Preservation Department – Item 3, LPC-26-05571

**250 2nd Avenue – Stuyvesant Square Historic District
Borough of Manhattan**

Manhattan Public Restroom Building

NYC Landmarks Preservation Commission Review
July 28, 2026

Stuyvesant Square East | 2 - Benches on inner curve - Comparison Slide

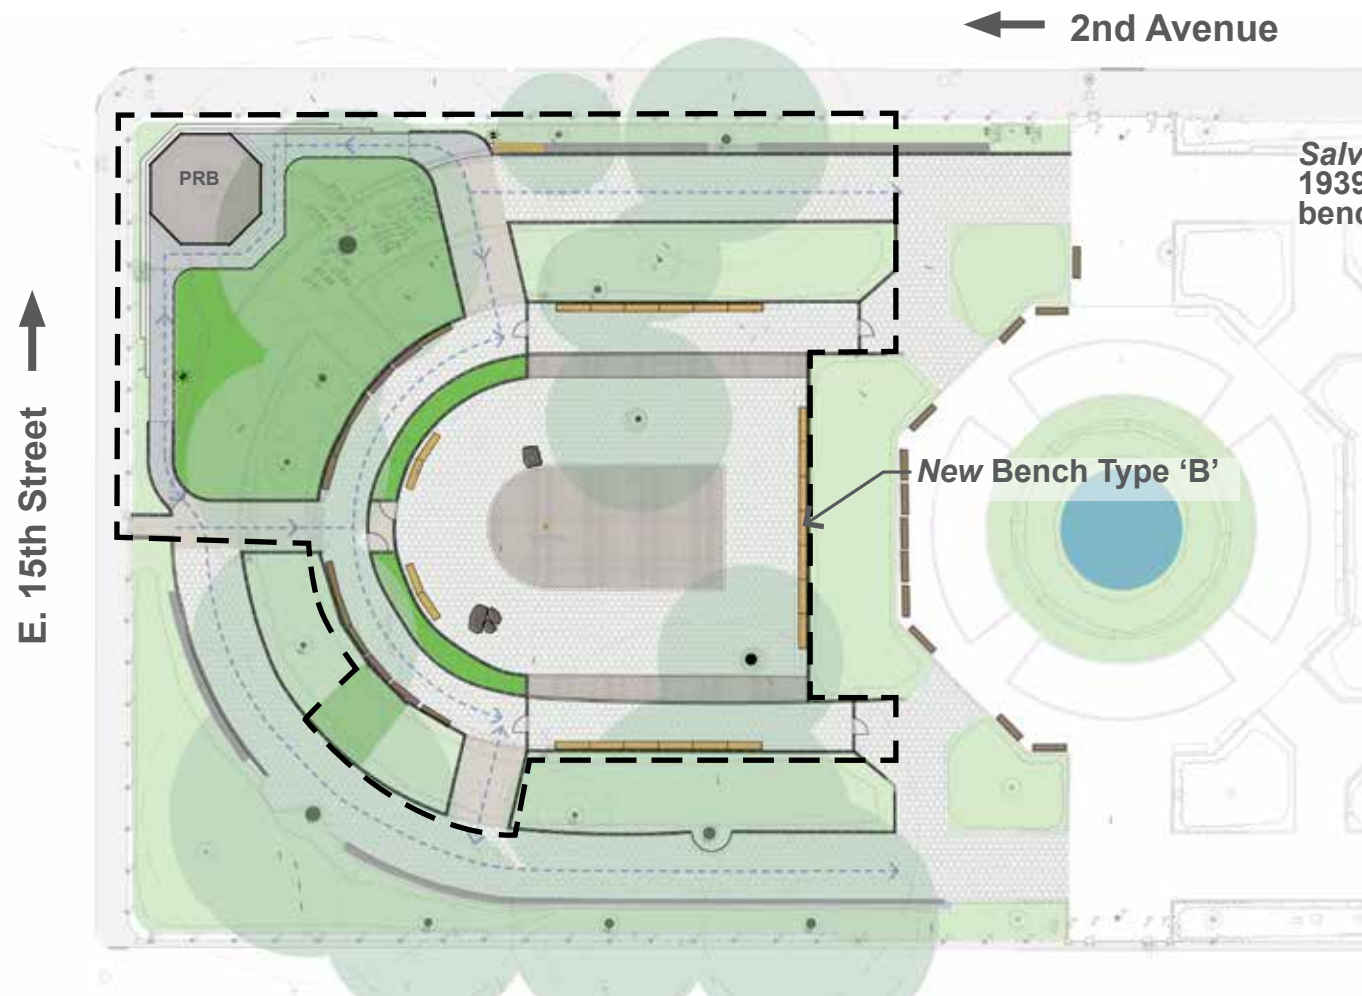
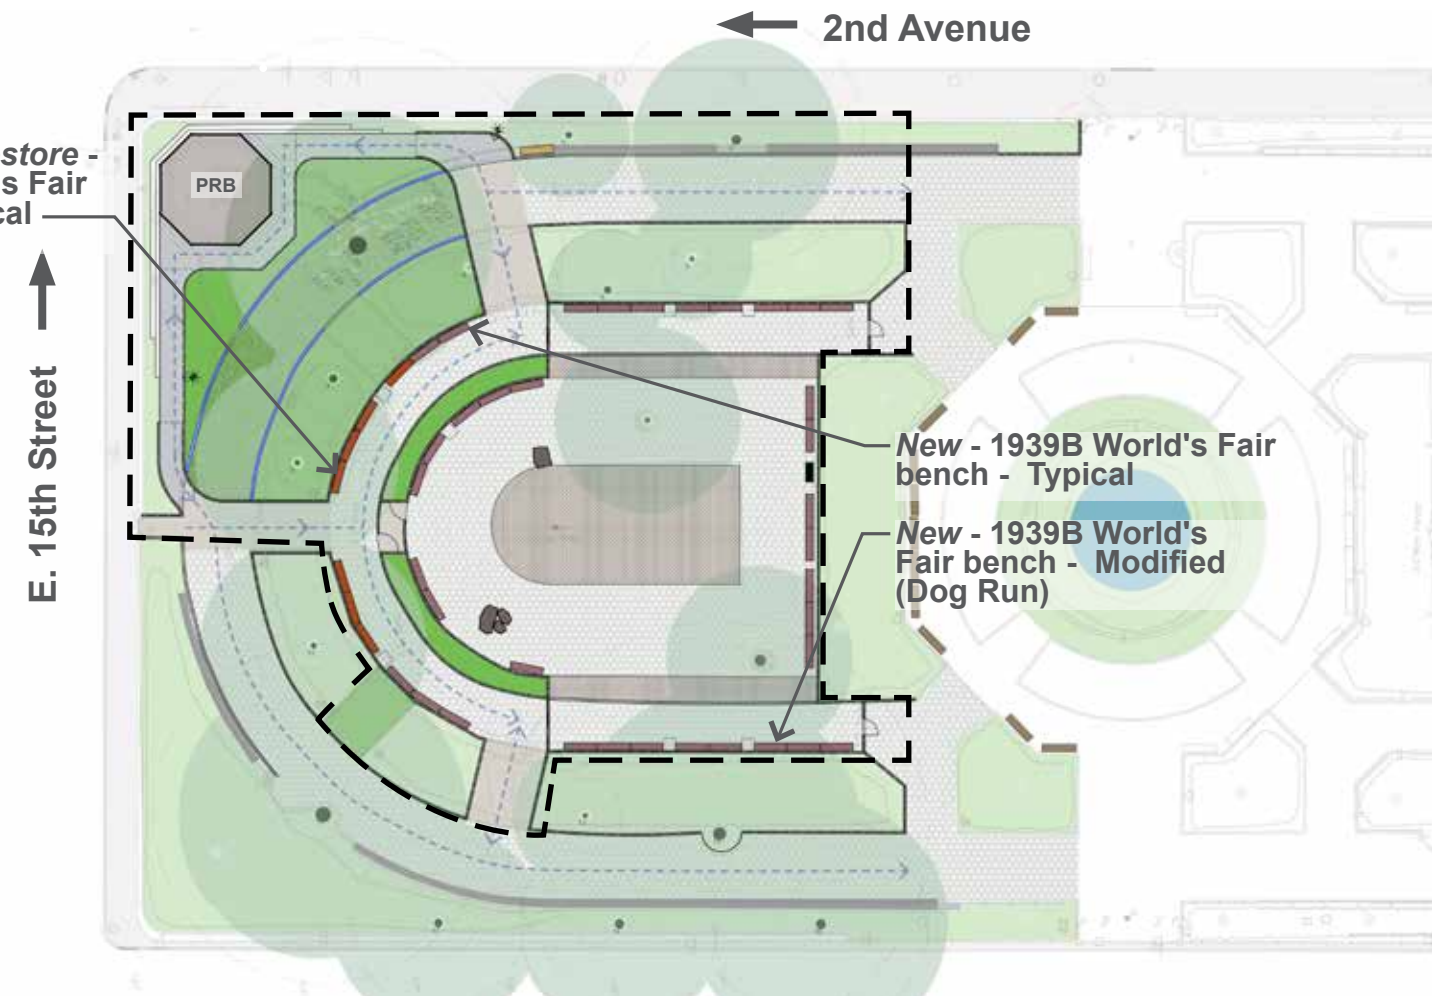
Commissioner Feedback:

1. Benches on Inner Curve – Replace the previously proposed Bench Type B (concrete base) in the dog run with 1939 World's Fair benches along the inner pathway.

Reponse:

1. Revise proposed bench type to be 1939B World's Fair (Typical for inner walking path, Modified for dog run)
2. Salvage and restore some 1939A World's Fair Benches and replace deteriorated benches with new 1939B World's Fair Benches (Typical for inner path, Modified front slat for dog run only)
3. Modified front wood seat slat at the dog run area to address paw safety concerns. (1939B World's fair Bench - Modified)

Proposed Bench Profile
"1939B World's Fair - Modified"
has modified front slat for dog run

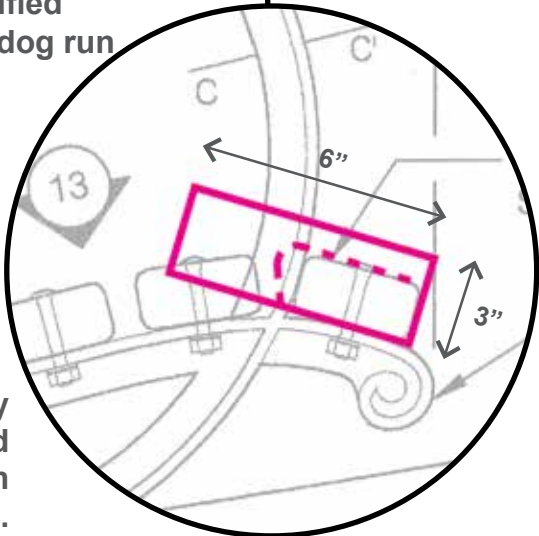
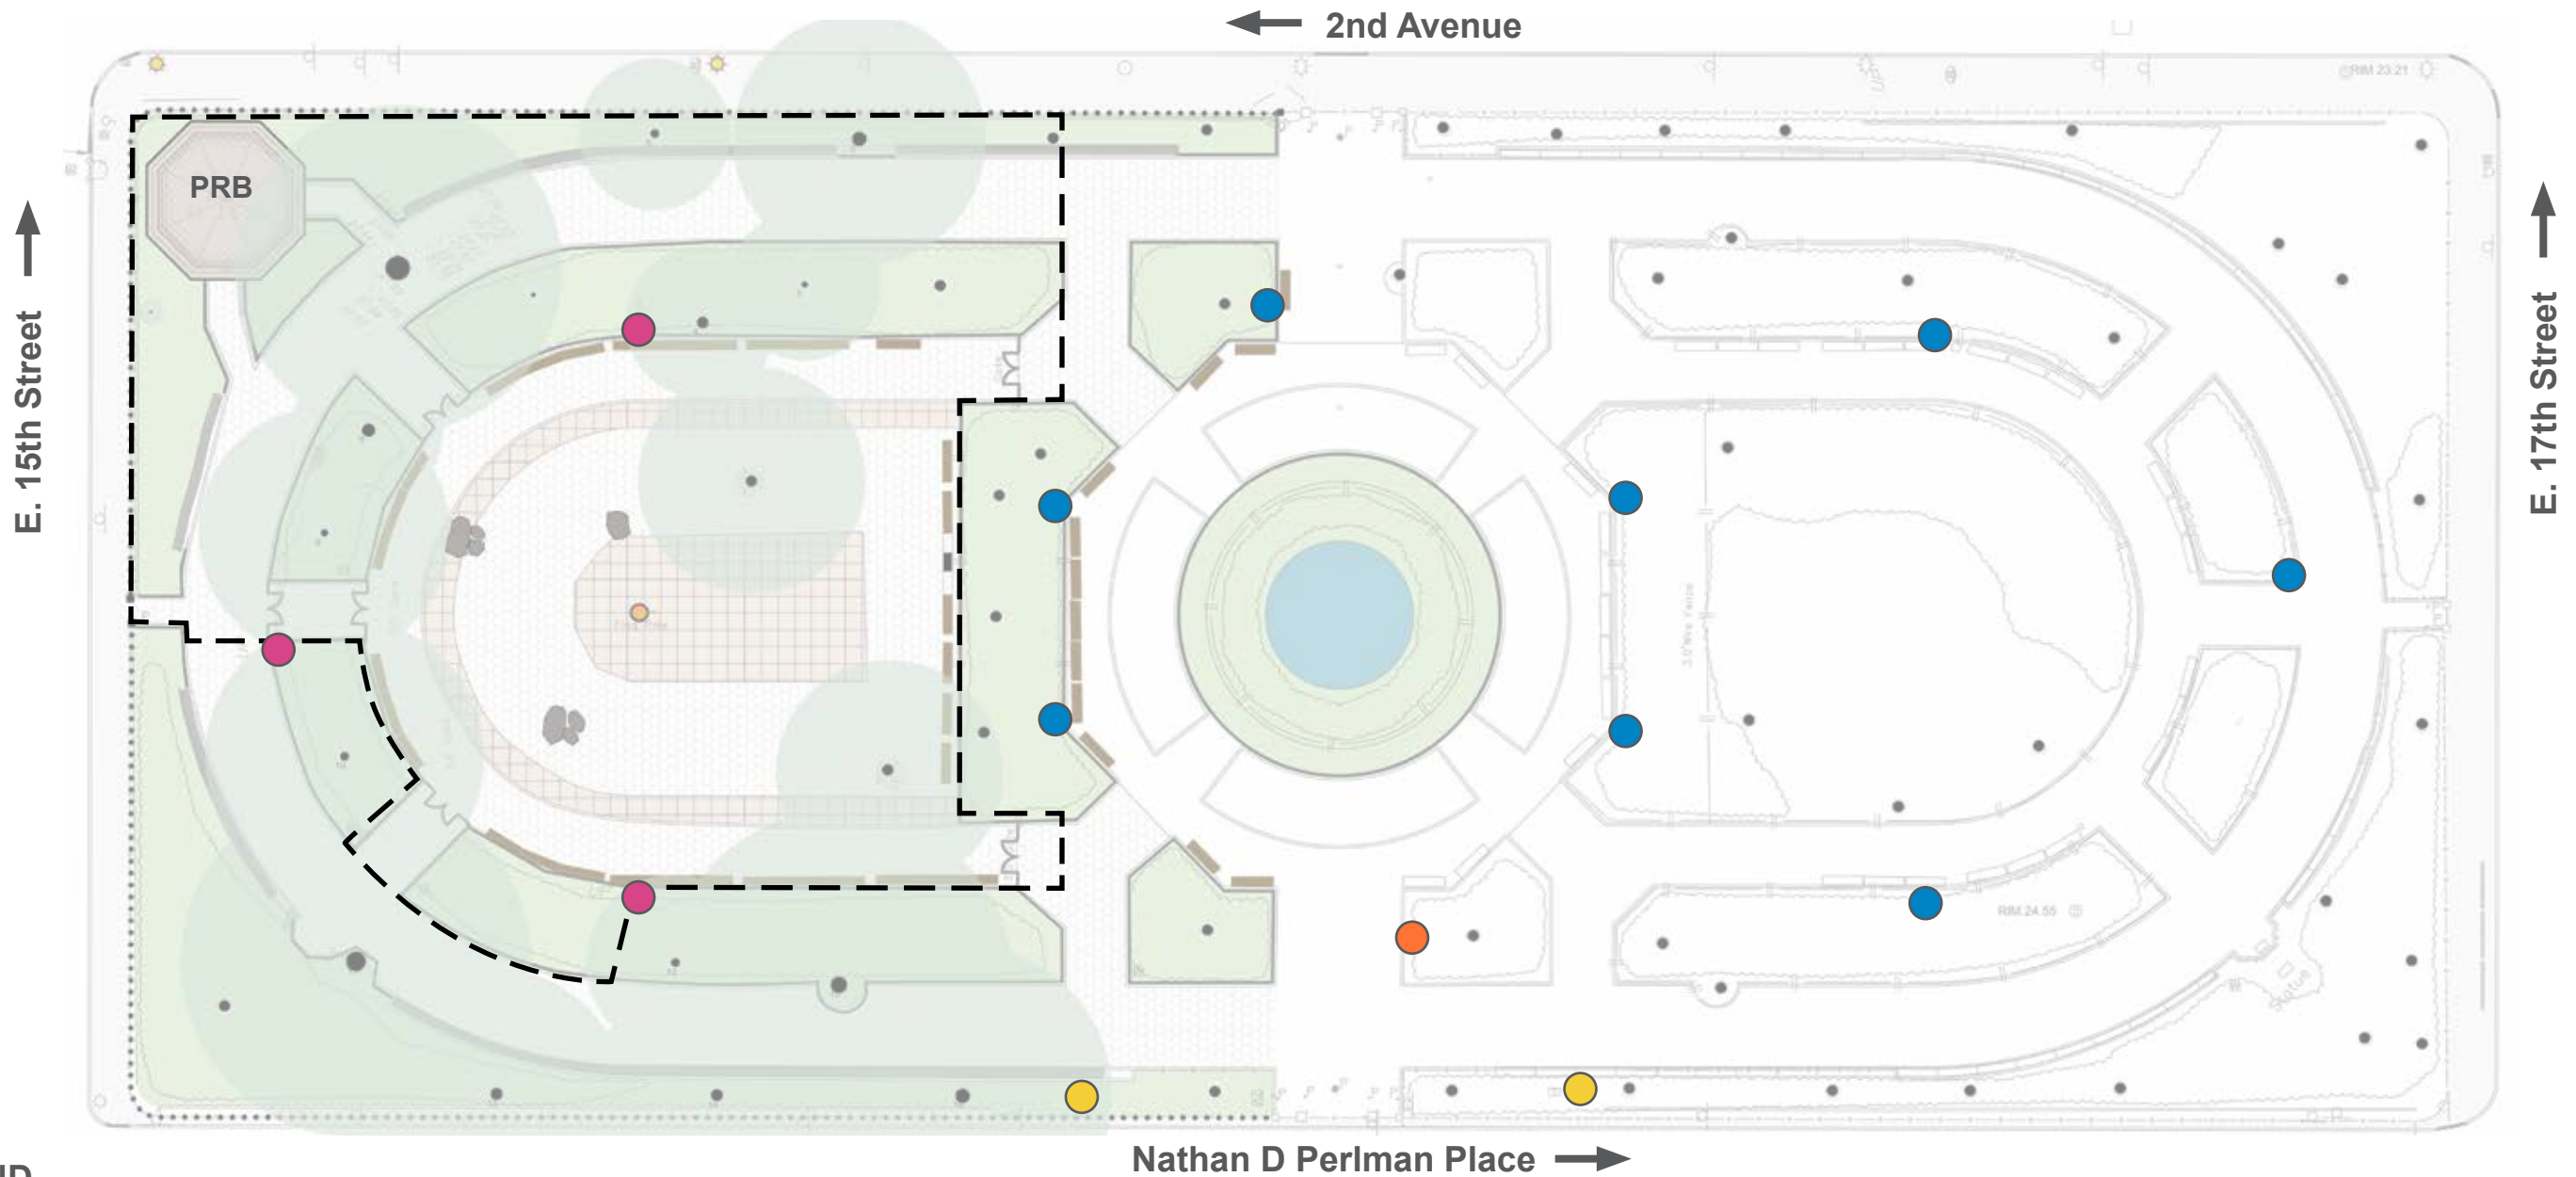
Commissioner Feedback:

Research the commercial availability of historic
light pole style with decorative top element.
